ATTACHMENT 1 TO TXX-06125
RESPONSES TO REQUESTS FOR ADDITIONAL INFORMATION
FOR THE REPLACEMENT STEAM GENERATOR SUPPLEMENT
TO TXU POWER'S LARGE AND SMALL BREAK
LOSS OF COOLANT ACCIDENT ANALYSIS METHODOLOGIES

July, 2006

ERX-04-004, "Replacement Steam Generator Supplement to TXU Power's Large and Small Break Loss of Coolant Accident Analysis Methodologies."

Figure A-1 Primary and Secondary System Pressures – 3-in Break

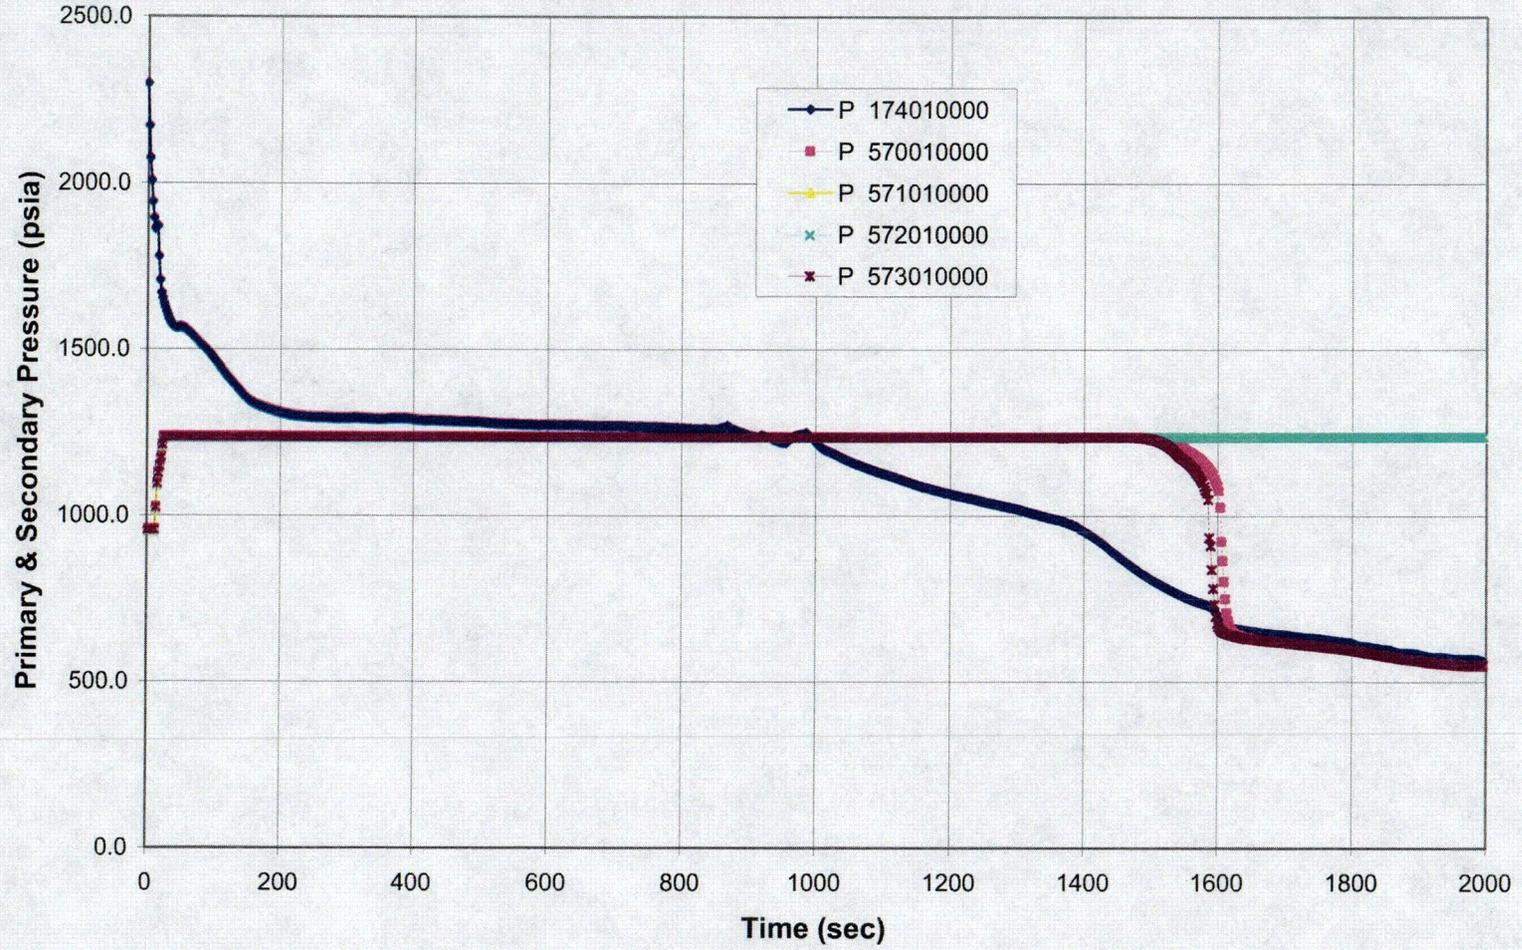
During a June 14 phone call the NRC asked TXU to confirm that the oxidation acceptance criteria of 10 CFR50.46 for SBLOCA are addressed in the methodology. Also, a concern was brought up that is allayed by what has been discussed above about the CPSES SBLOCA terminating by accumulator injection. The concern was the theoretical possibility of the core remaining uncovered for a long time with clad temperatures below the PCT, but high enough to challenge the oxidation acceptance criteria. These requests are addressed in the following:

- (1) System depressurization rates are relatively fast, even for the smallest breaks, e.g. the 3" break shown in Figure A-1. Even for the smallest breaks, the ultimate rod quench is due to accumulator injection. Thus, the clad temperature turns around very quickly once the relatively high accumulator set point pressure is reached (again see Figure A-1 for the 3" break).
- (2) The limiting power shapes peak very near the top of the core. For the temperatures to linger at relatively high values, the uncovered portion of the core would have to be above the peak node, but below the top of the core. When the level is below the peak power node, the temperature increases at the rates seen in the smaller breaks, e.g., the 3" break shown in Figure A-7. Obviously, if the level is above the top of the core

Figure A-15 Hot Assembly Steam Temperatures – 3-in Break

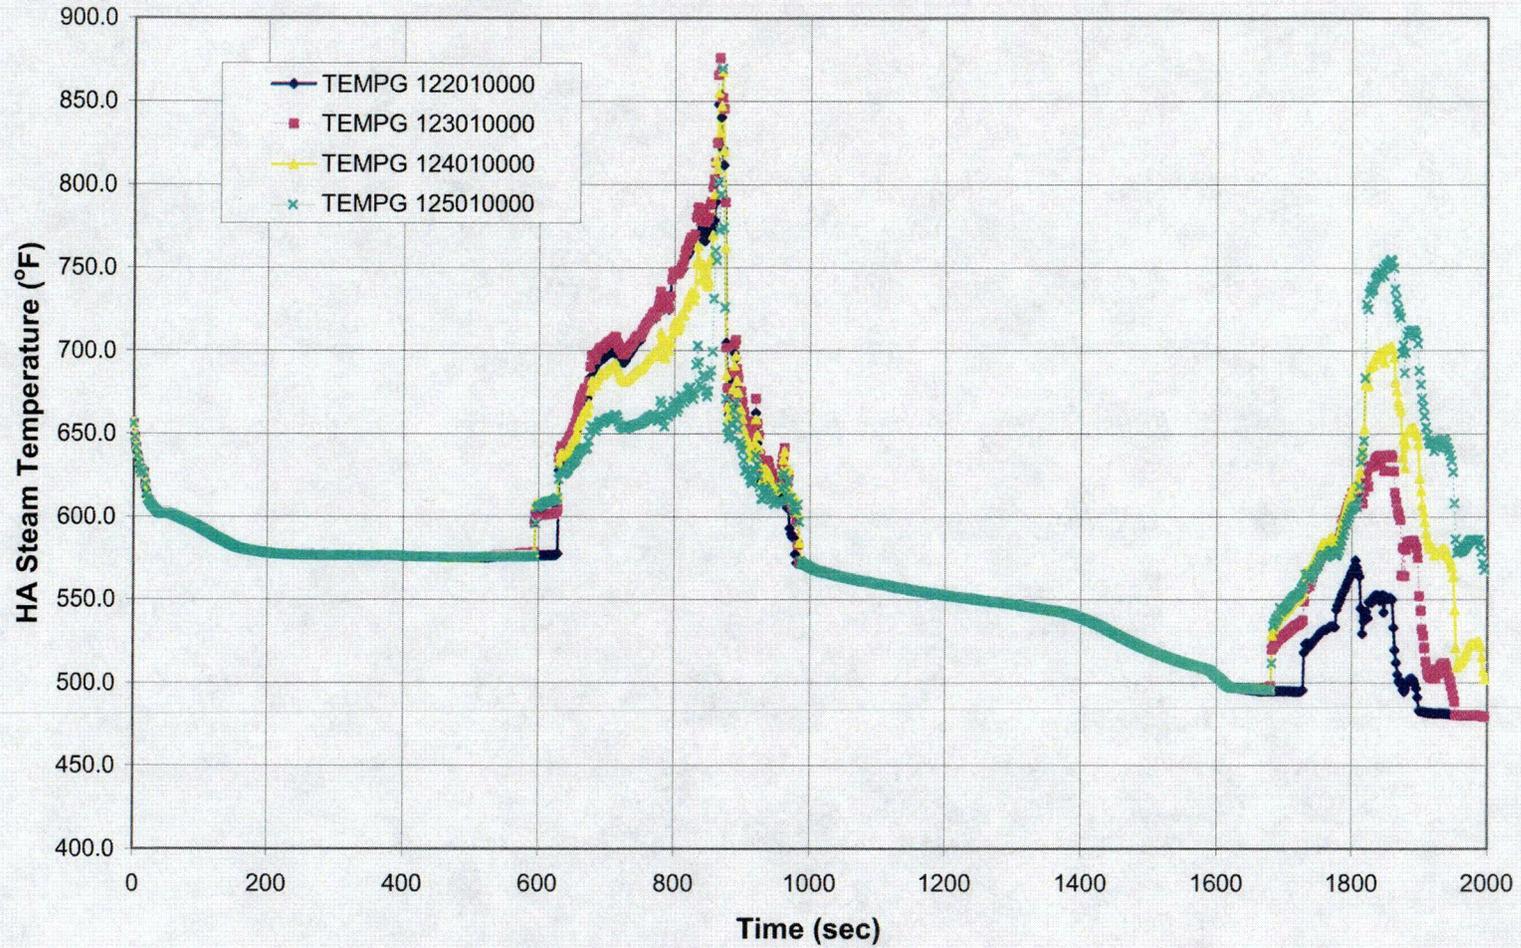
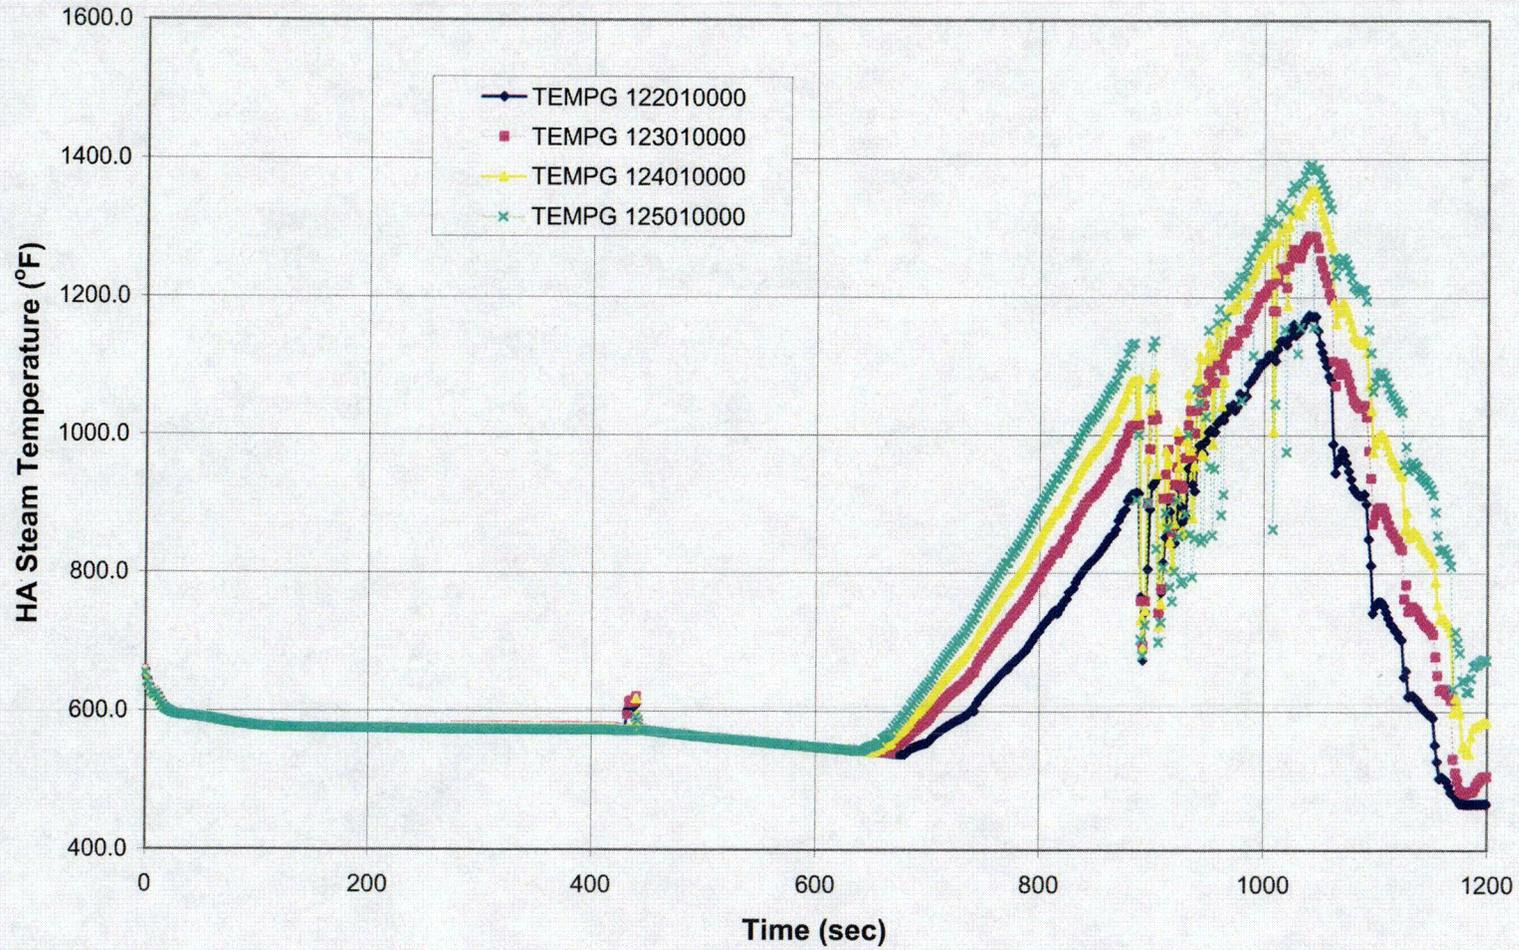
- j. **Demonstrate that above the two-phase level no liquid is entrained in the steam leaving the two-phase surface via the drag model in RELAP5 that would artificially de-superheat the steam at the hot spot for the limiting SBLOCA.**

Also, the additional figures requested in Q7.a.iii include the steam temperatures adjacent to the hottest clad temperature nodes. Plots of those temperatures (Figures 15 of the A through J sets, i.e. A-15, B-15... J-15) provided in the section: “COMPLETE SETS OF PLOTS FOR ADDITIONAL CALCULATIONS” show the steam is highly superheated with temperatures following those of the adjacent cladding.

Figure B-7 Hot Assembly Clad Temperatures – 4-in Break

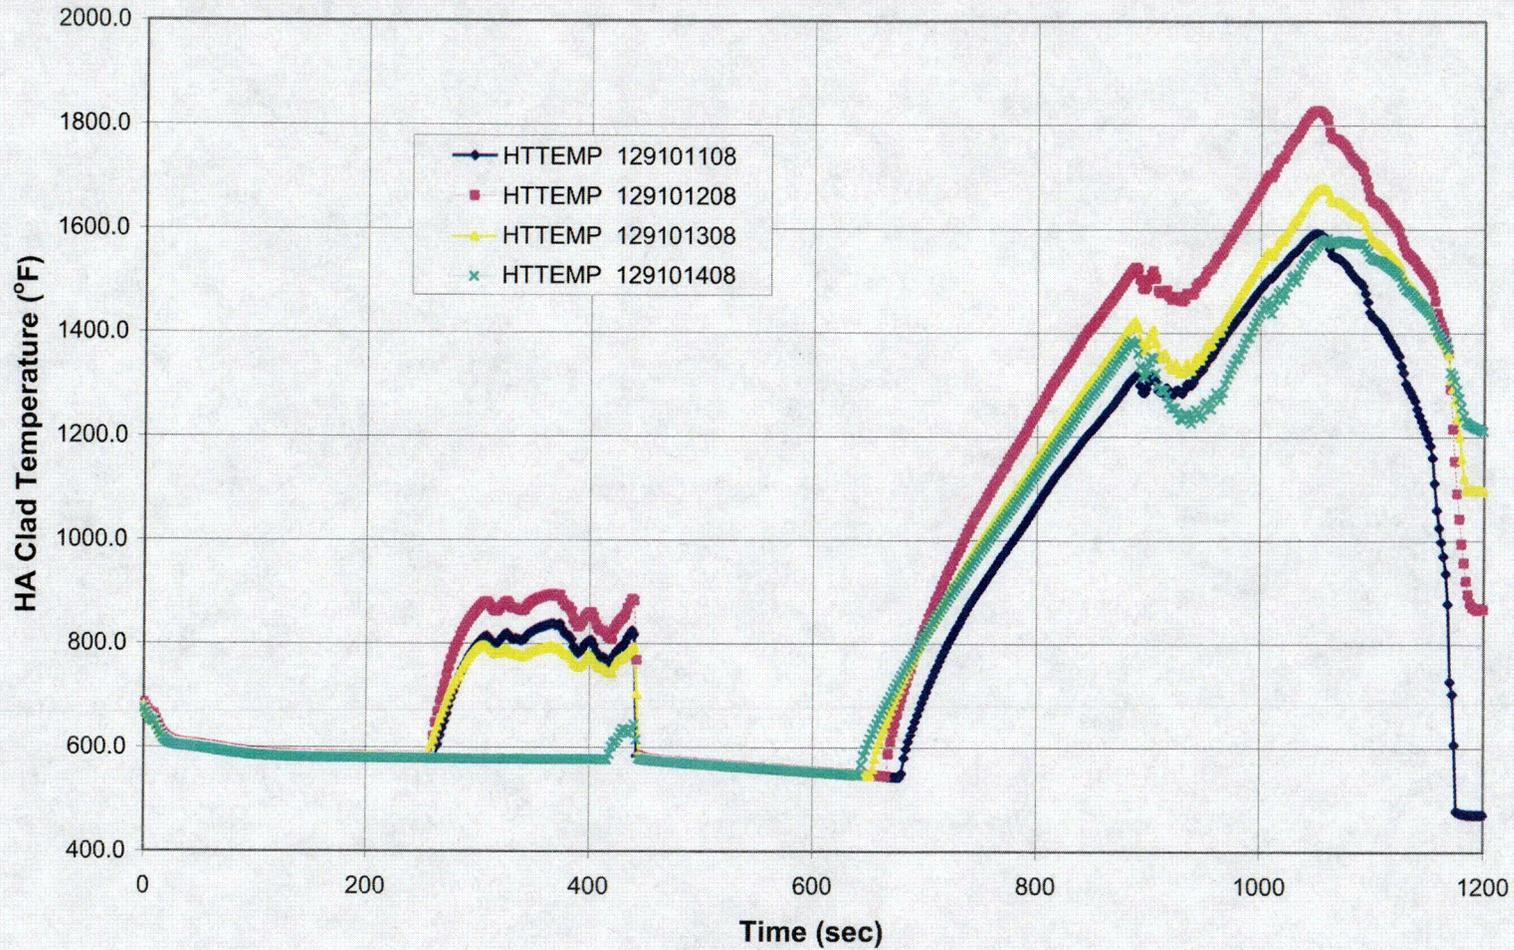
At a June 14 phone call the NRC asked what causes the dip in clad temperature around 900 seconds seen for example in Figure B-7, corresponding to the clad temperatures for the limiting 4inch break base case. This inflection is due to water redistribution between the Hot Assembly, Central Region and Average Core. Figures B-2, B-3 and B-4, respectively, show void fractions at three core elevations: bottom (nodes, 112, 130,150), lowest $\alpha = 1$ elevation (nodes, 122, 140, 160) and an intermediate elevation (nodes, 117, 135, 155) in each of these three core regions. At the time period of interest, around 900 seconds, the topmost elevation (nodes, 122, 140, 160) remain at $\alpha = 1$. This shows that no water has entered either of these three core regions from the top. Further evidence of this is provided in Figure B-5 that shows no liquid at this time in the upper plenum either. Similarly, there is no significant trend change in the void fractions in the lower elevations (nodes, 112, 130,150). Additional inspection of mass flow rates from the lower plenum to the various core regions (flows from volume 111 to 112, 130 and 150) also show no change over the period of interest. These observations indicate there was no change in the amount of water entering these three core regions either from above or from below. A look at the void fraction behavior at the intermediate elevation (nodes, 117, 135, 155) however, is revealing. While similar oscillations in void fraction are seen at that elevation in all three regions, the highest void fractions occur in the average core region, then in the central region and finally in the hot assembly. This hierarchy indicates net water movement away from the larger regions towards the hot assembly at intermediate elevations. A look at representative cross flows during the period of interest shows a step reduction in the outflow from the hot assembly. Figure B-15 shows a reduction in the hot channel superheat about the PCT elevation which is consistent with more of the upstream flow remaining in the hot assembly. Thus, these observations indicate that the inflection in temperature is due to a redistribution of flow between the various core regions, where outflow from the hot assembly region is temporarily reduced to satisfy energy and momentum conservation equations, most likely compensating for an earlier overshoot. Note that the cross flow resistance study (Figure 4.37 of Reference 3) identifies the limiting cross flow resistance. Heat transfer and flow regime flags in the core were examined but no significant changes occurred during the time period of interest that could account for the inflection in the clad temperature history.

As shown in Figures A-7, B-7, C-7, D-7, E-7, G-7, H-7, I-7, J-7, for breaks of 3", 3.76", 4", 4.22", 5" and various sensitivities, the CPSES SBLOCA clad temperatures increase nearly monotonically¹ and rapidly after CHF in all cases. Mechanisms that might keep the rods at relatively high but constant temperatures, i.e., that would prevent rod temperatures from increasing rapidly in post CHF heat transfer mode are not operative during CPSES SBLOCA for two main reasons:
